DRAWING AMENDMENTS

Please replace the current version of Figure 1 and Figure 4 with the following Replacement Figures 1 and 4.

APPLICATION NO. 10/670,540
 REPLY TO OFFICE ACTION OF MARCH 27, 2006
 REPLACEMENT SHEET

FIG. 1

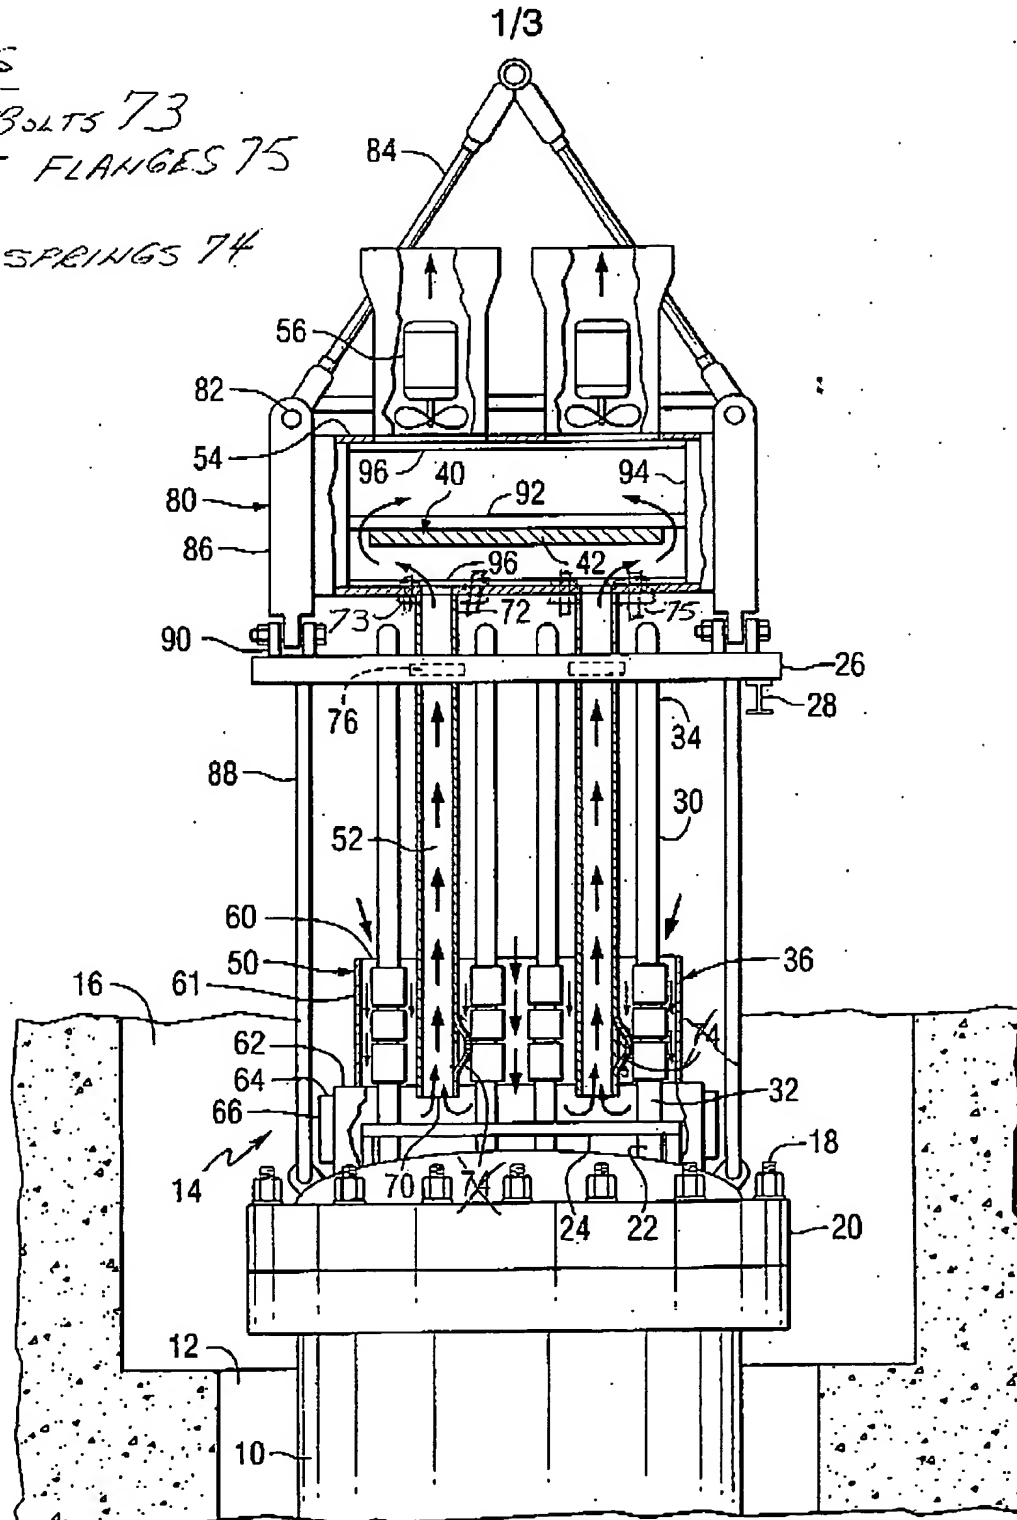
The Applicants note that the submitted version of Figures 1 and 4 incorporates two changes from the previously submitted version. The first change (to Figure 1 only) added bolts 73 and flanges 75 to the internal ducts 52. This structure is discussed in the specification at page 5, lines 14-17, and in the above Specification Amendments.

The second change is made (to both Figures 1 and 4) in response to the Examiner's suggestion at page 4, Paragraph 3(d) of the outstanding Office Action. Accordingly, Item No. 74 is deleted and the internal ducts 52 do not show a spring 74.

Figures 1 and 4 have been amended in accordance with the Examiner's suggestion of Subparagraph (d) to delete a reference to Item (74) and the depiction of a "resilient spring".

- ① ADDED BOLTS 73
 IN DUCT FLANGES 75
- ② DELETED SPRINGS 74
